Development Review Comments

PAM2023-00150

Address – 5906 Halpine Road

PRE–APPLICATION SITE PLAN ROCKVILLE (4TH.) ELECTION DISTRICT MONTGOMERY COUNTY, MARYLAND

SHEET NO. **PSP-3**

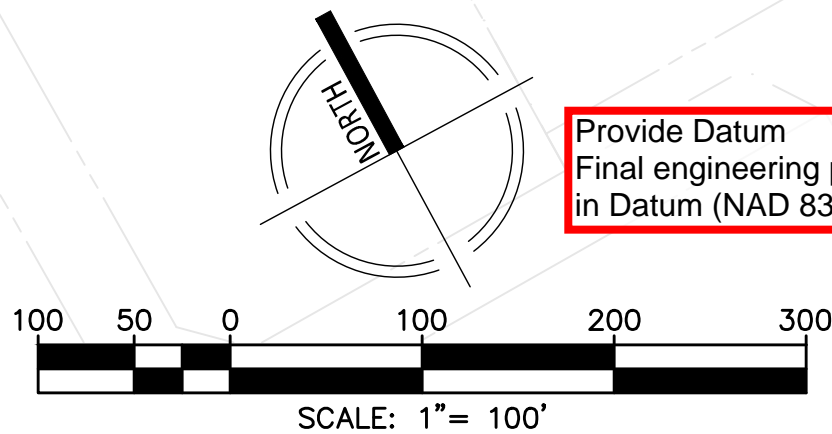
Forestry:

1. Staff anticipates that a Forest Conservation Plan will be required for this site, including Forest Conservation, Minimum Tree Cover and Significant Tree Replacement requirements.

2. Please be advised there are forest conservation easements for both neighboring properties at Twinbrook Commons and Halpine Square. During the review process staff will be looking to ensure credited trees in easements are preserved.

Per Sec. 25.13.05.b.1, rear setbacks abutting residential land must have a minimum setback of 25' or height of building, whichever is greater. Site is abutting residential on its non-frontage sides, requiring the specified setback as described here.

Per 25.16.05.b.7, the Approving Authority may allow parking spaces on private streets to be applied toward the total parking requirement for the development in considering a project plan or site plan. It does not appear that the applicant is proposing this and it is unclear where the indicated street parking is located.

Provide Datum
Final engineering plans must be in Datum (NAD 83/91, NGVD 88)

A Water & Sewer Authorization must be approved prior to Site Plan approval. Submit completed Water & Sewer Authorization application with applicable fees.

- Modeling of the new water may be necessary. DPW will coordinate with consultant who provides water system modeling services for a time/cost estimate on the work.
- Generally dead-end water mains should be avoided.
- The City generally follows WSSC Pipeline Design Manual for sizing, structures, clearances, crossings etc.

Preliminary Sediment Control Plan must be approved prior to Site Plan approval. Submit application with applicable fees.

Provide layout per ordinance 25.17.03a. All underground lines and cables shall be placed in a public utility easement, or otherwise on private property. No utilities may be placed in the public right-of-way or on City property without the express written permission of the City, and subject to such terms and conditions that the City may require.

Dry utilities may cross the ROW perpendicular.

Applicant shall submit a conceptual dry utility plan that will be required to be approved by both the utility companies and DPW at Site Plan.

Pre-App SWM Concept is under review. Pre-App SWM Concept cannot be approved until the NRI/FSD is approved.

Pre-App SWM Concept must be approved prior to submission of the Development SWM Concept. Site Plan cannot be submitted until the Pre-App SWM Concept is approved.

The Pre-App SWM Approval letter will establish the study points of the safe conveyance analysis.

Development SWM Concept must be approved prior to site plan approval.

Safe Conveyance Study must be approved prior to site plan approval. The Pre-App SWM Approval letter will establish the study points of the safe conveyance analysis. However, this analysis may be concurrent with the Development SWM Concept.

SHEET NO. PSP-5

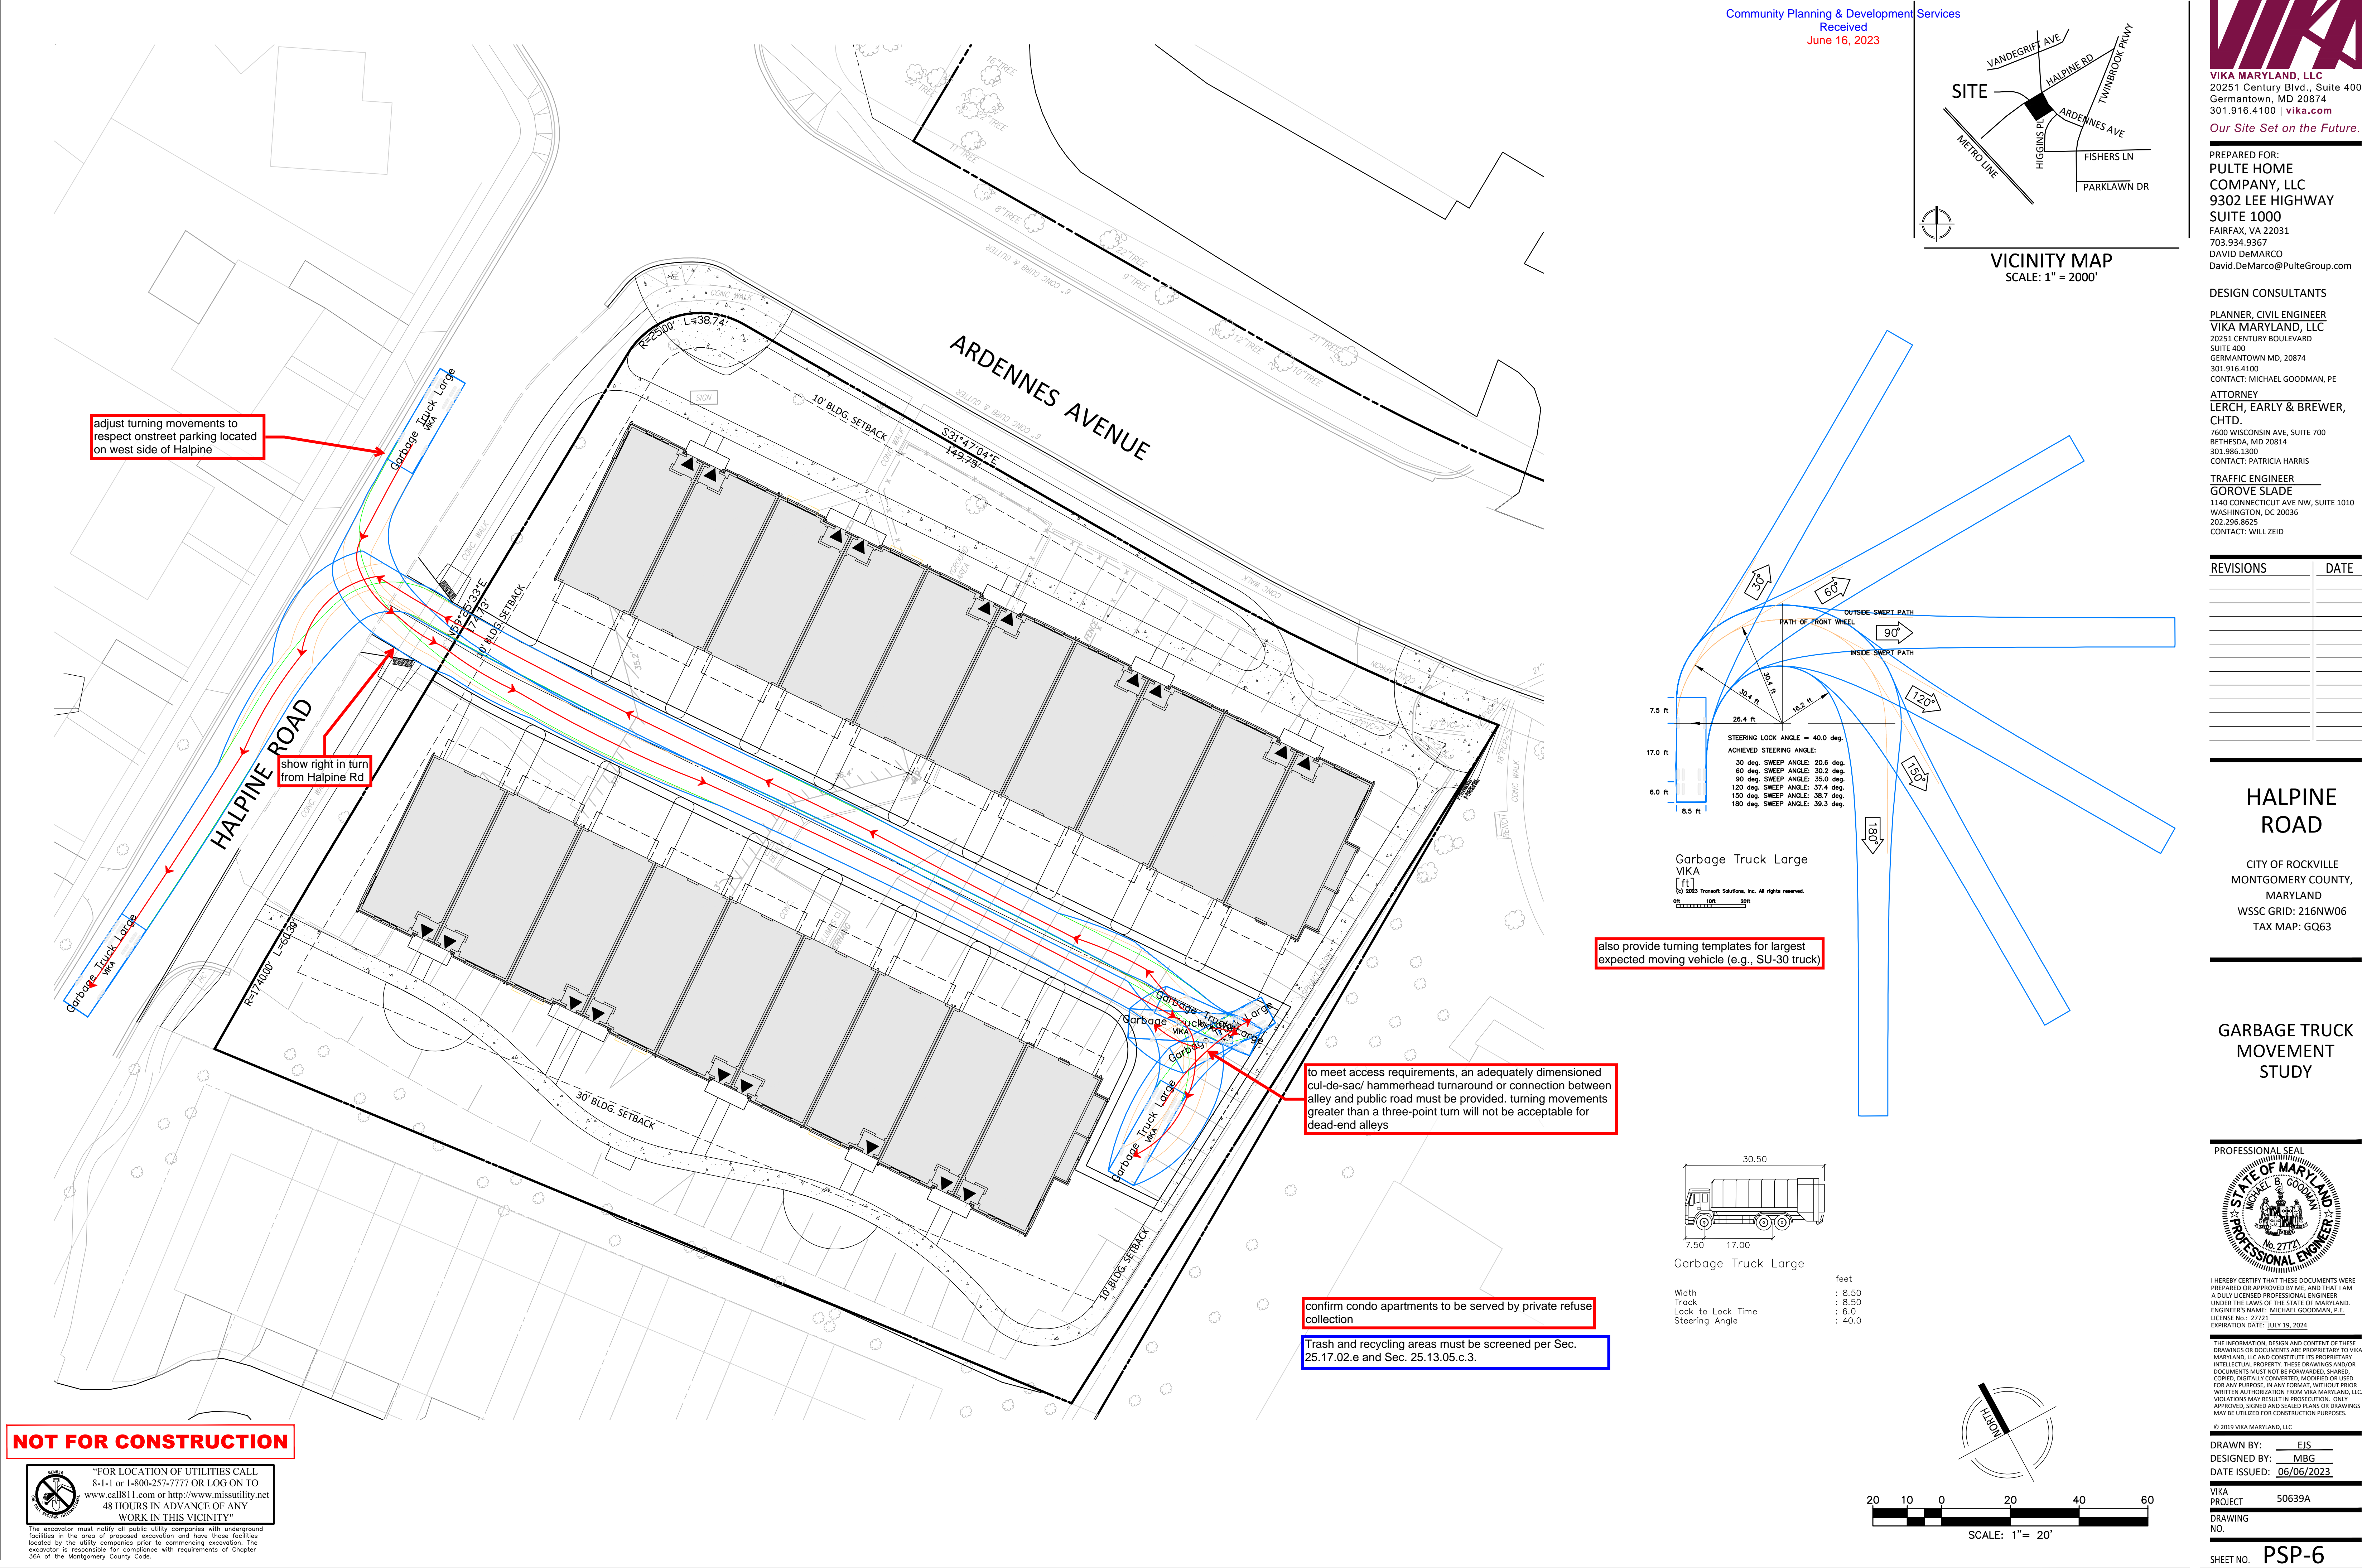
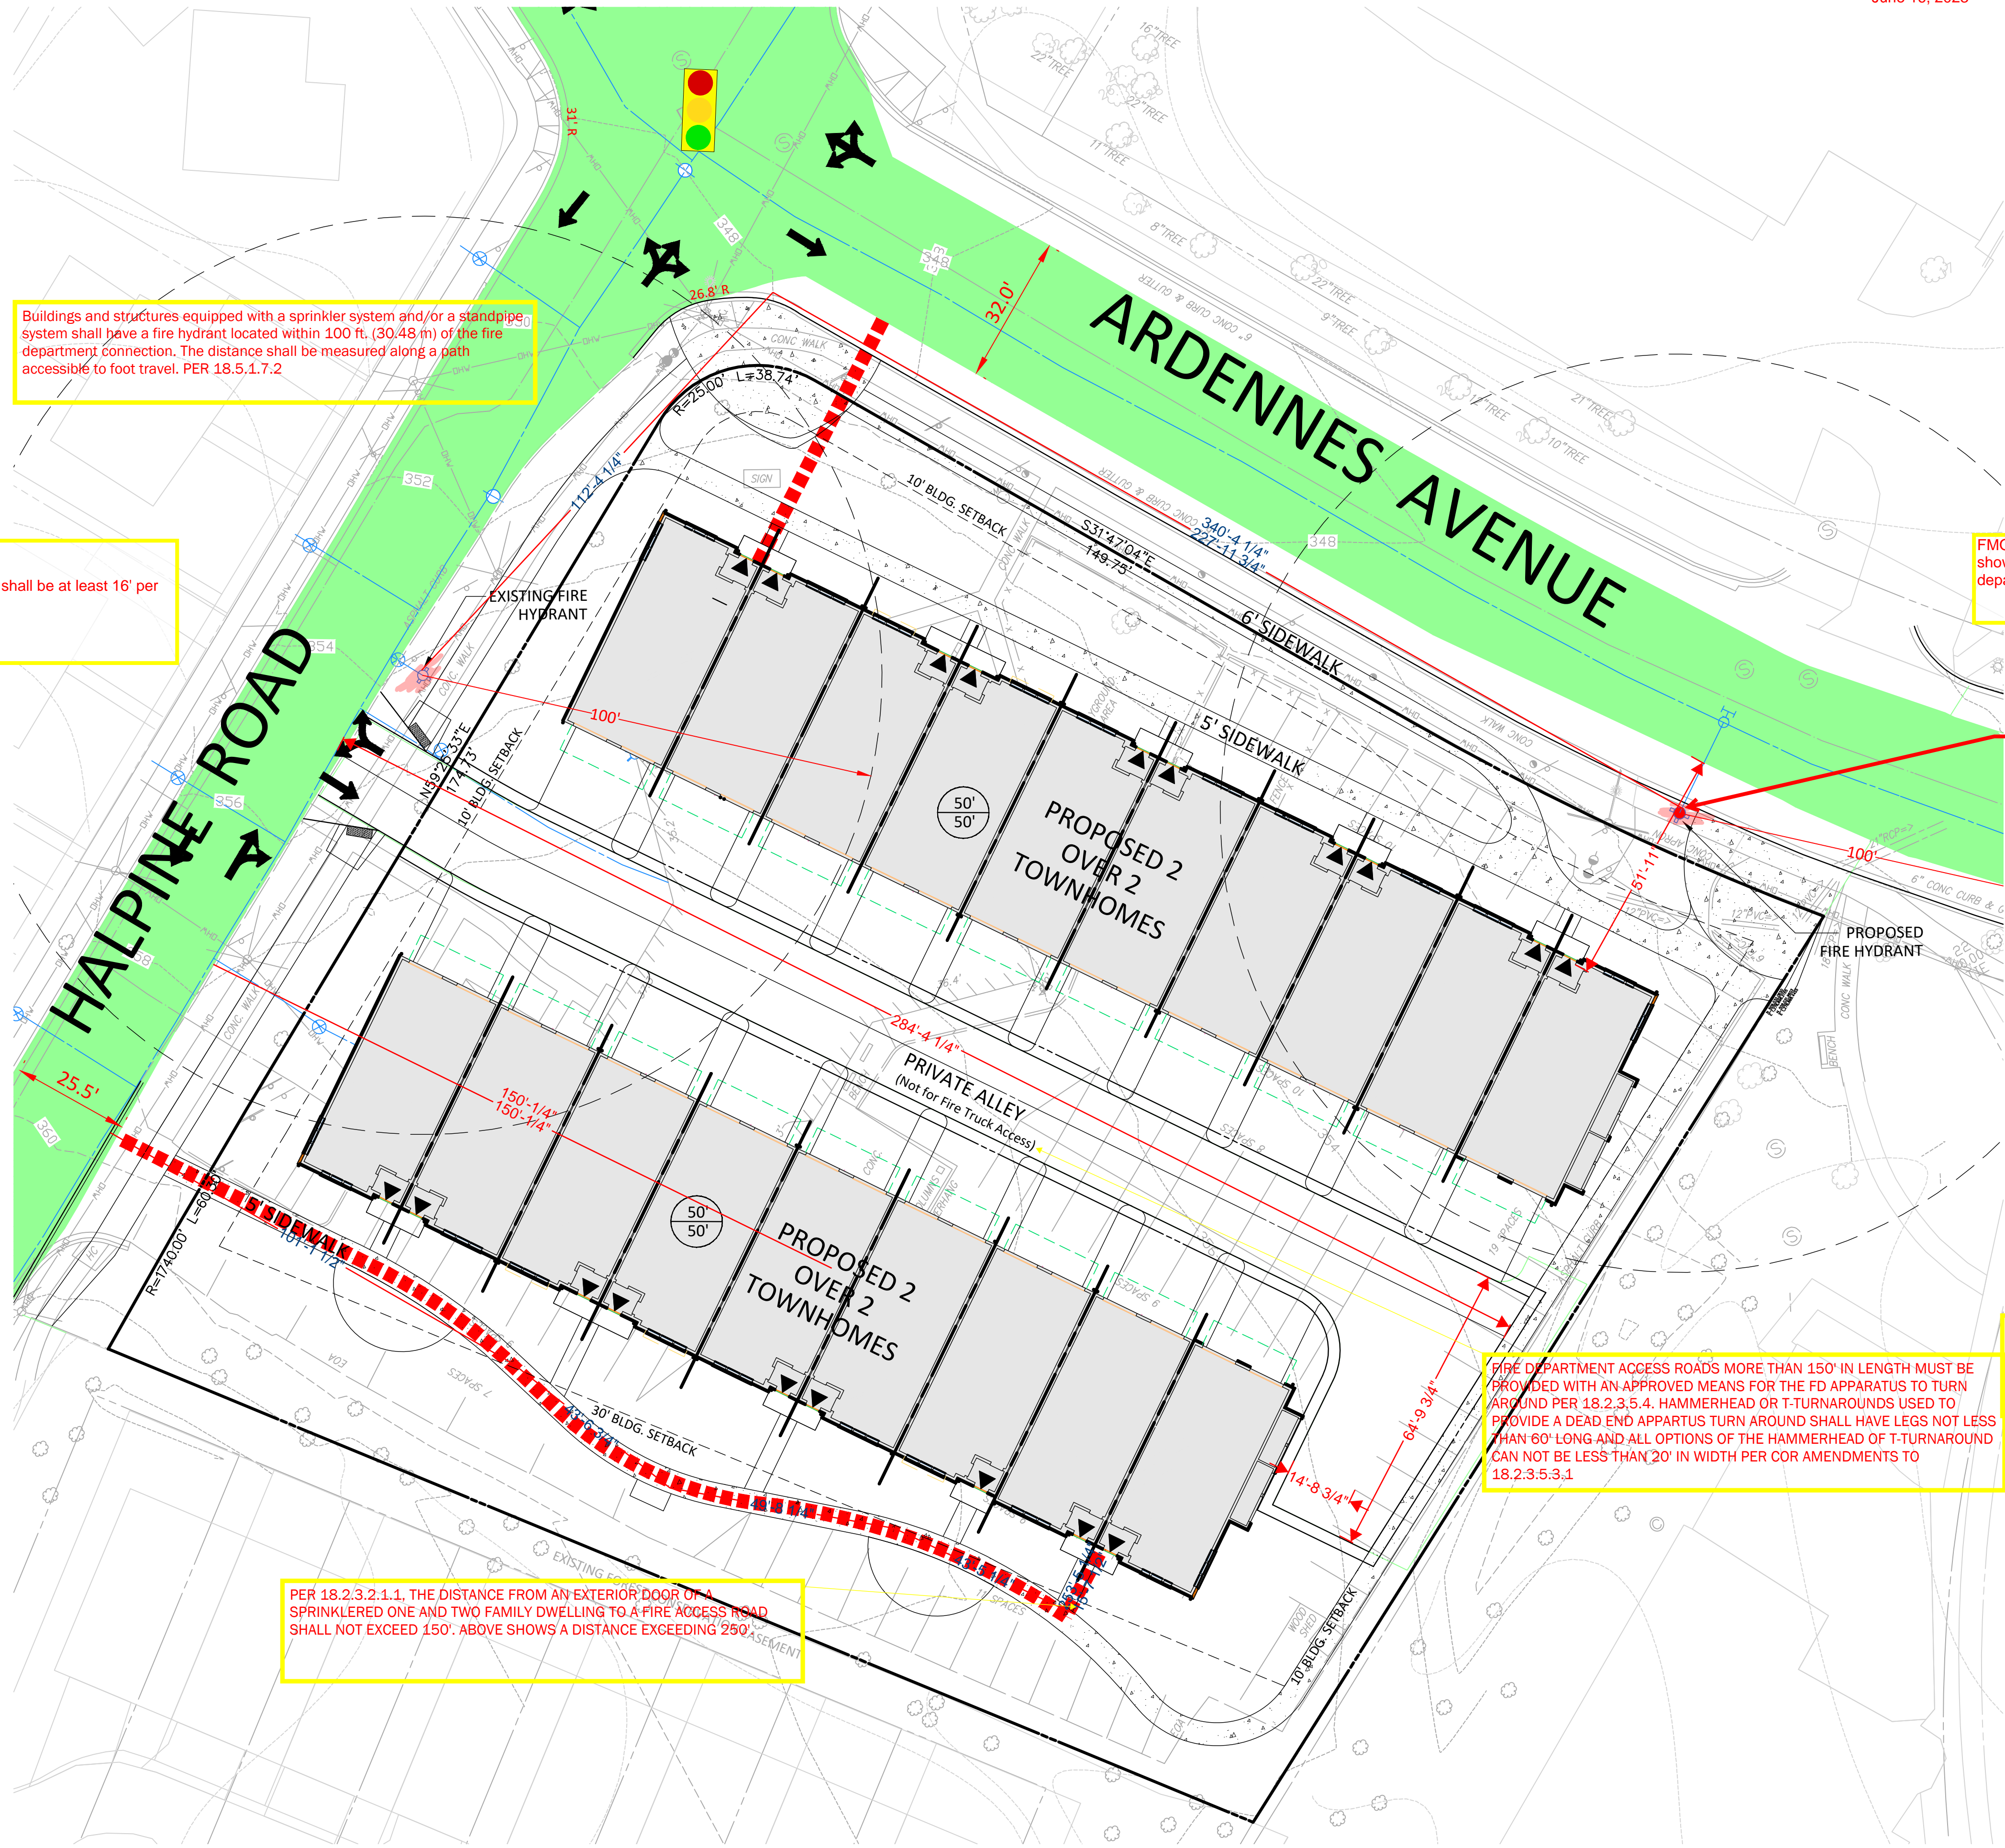
- 10"W WATER LINE AND FITTING
- FIRE HYDRANT
- BUILDING ENTRY
- FIRE ACCESS PATH
- FIRE ACCESS WALKABLE PATH
- THE "WALKABLE PATH" IS TO REPRESENT THE ROUTE FD PERSONNEL WOULD REASONABLY TRAVEL AROUND THE BUILDING IN THE COURSE OF FIREFIGHTER OPERATIONS. IT APPEARS THIS DISTANCE IDENTIFIED IS SHOWING THE DISTANCE FROM THE FIRE ACCESS ROAD TO THE EXTERIOR DOOR. THIS IS NOT THE WALKABLE PATH. PLEASE CORRECT.
- BUILDING HEIGHT ALLOWED
- BUILDING HEIGHT ILLUSTRATED
- CONCEPTUAL DOORWAY LOCATION
- EXISTING TRAFFIC SIGNAL
